GENERAL INFORMATION

Applicant:	SICK Product & Competence Center Americas, LLC (applicant) City of Bloomington (owner)
Location:	8050 Winstead Way, 2701 American Blvd. E., 8000 and 8051 26 th Avenue S.
Request:	Final Development Plans for Phase 2 of the SICK technology campus, an approximately 144,000 square foot office building and a parking structure, located at 8051 Winstead Way and 8051 26th Avenue E.
Existing Land Use and Zoning:	Technology campus and vacant land; LX(PD)(AR-17) Lindau Mixed Use (Planned Development)(Airport Runway AR-17)
Surrounding Land Use and Zoning:	North – Vacant; zoned C-4(AR-17) South – Office and financial institution; zoned LX(AR-17) East – Hotel and transit parking; zoned LX(PD)(AR-17); West – Hotels; zoned LX(AR-17) and LX(PD)(AR-17)
Comprehensive Plan Designation:	Lindau Mixed Use

PROPOSAL

Graphic 1: SICK Technology Campus Phases I and II

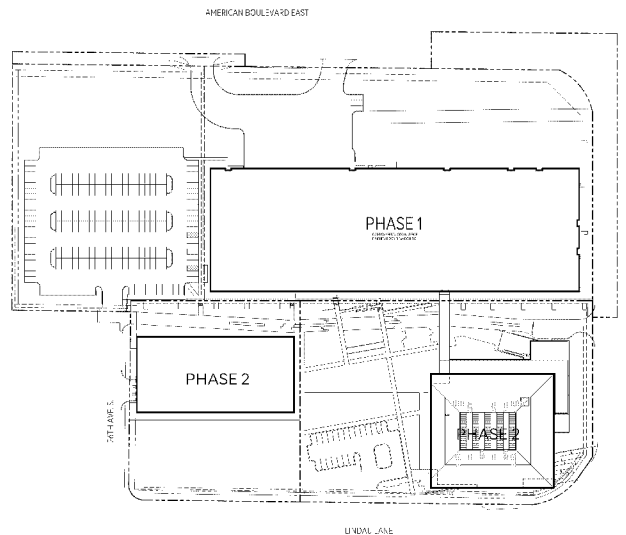
A technology campus is a conditional use in the LX Lindau Mixed Use zoning district. Phase II is consistent with the PDP, which was incorporated into the conditional use permit approval. A modification to the previously approved CUP is not necessary. Graphic 1 below depicts the proposed phase along with the recently completed Phase I. Graphic 2 depicts the four-phase technology campus.
